EXXON NUCLEAR COMPANY, Inc.

January 9, 1981

### Responses to Questions

Related to Environmental Information  
Submitted in Connection with Exxon Nuclear's License  
Renewal Application (SNM-1227, Docket No. 70-1257)

LAND USE WITHIN 50 MILE RADIUS OF EXXON NUCLEAR SITE

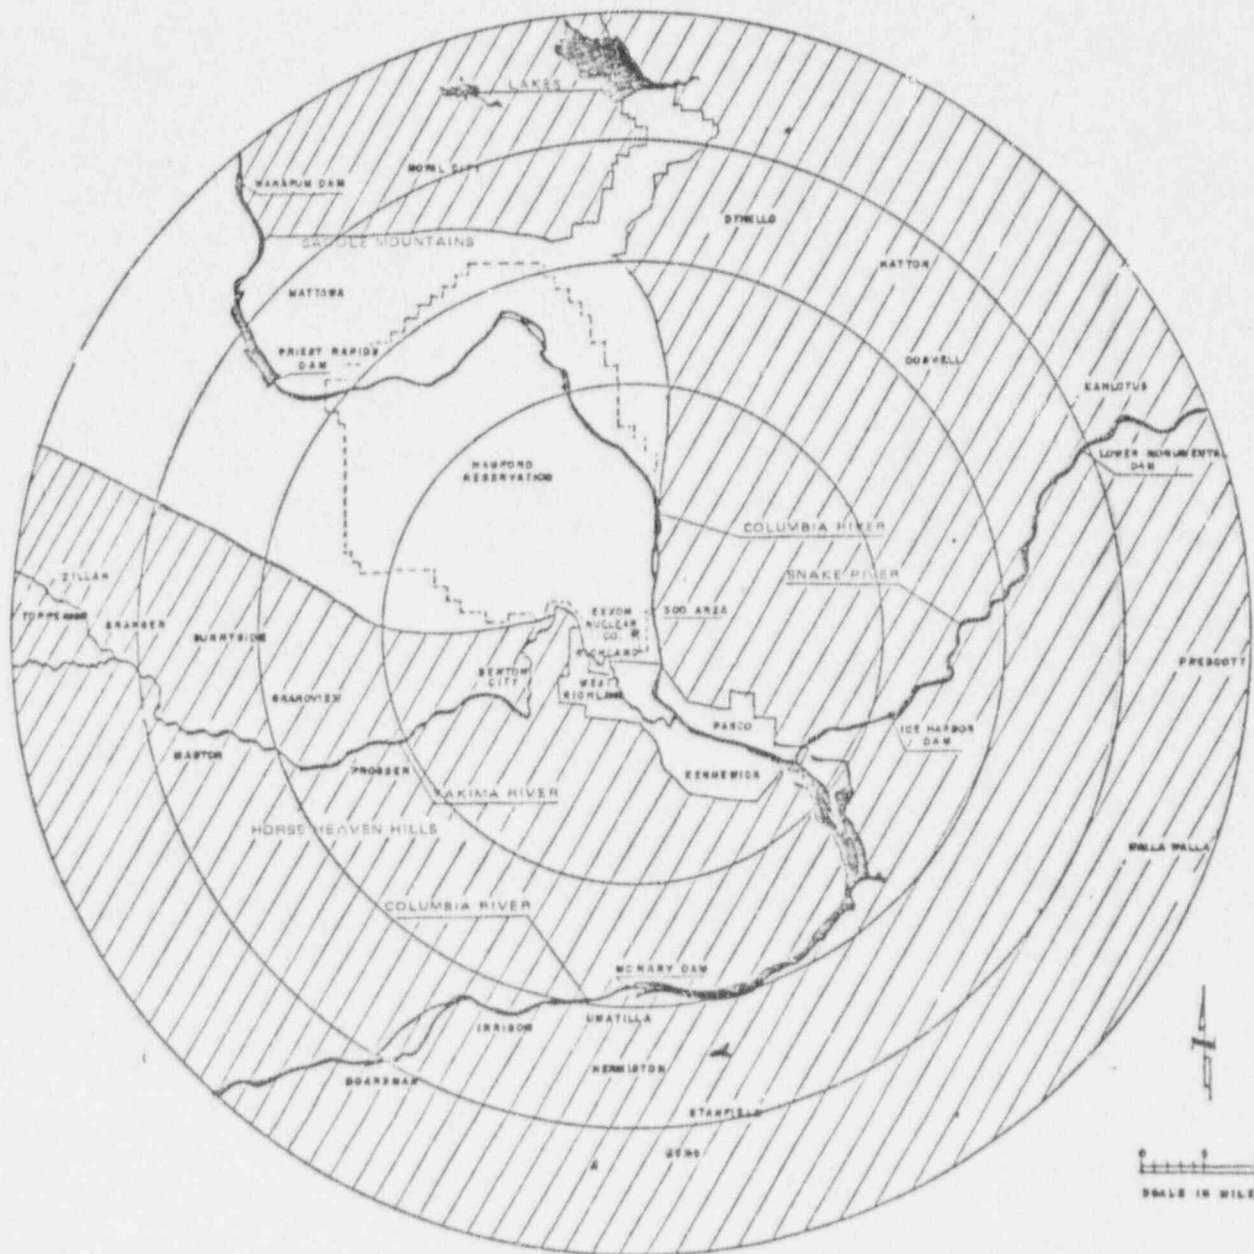
*What is the current land use pattern of the area within a 50-mile radius of the site?*

The current land use pattern of the area within a 50-mile radius of the Exxon Nuclear site is shown in Figures 1.3-1 through 1.3-3.
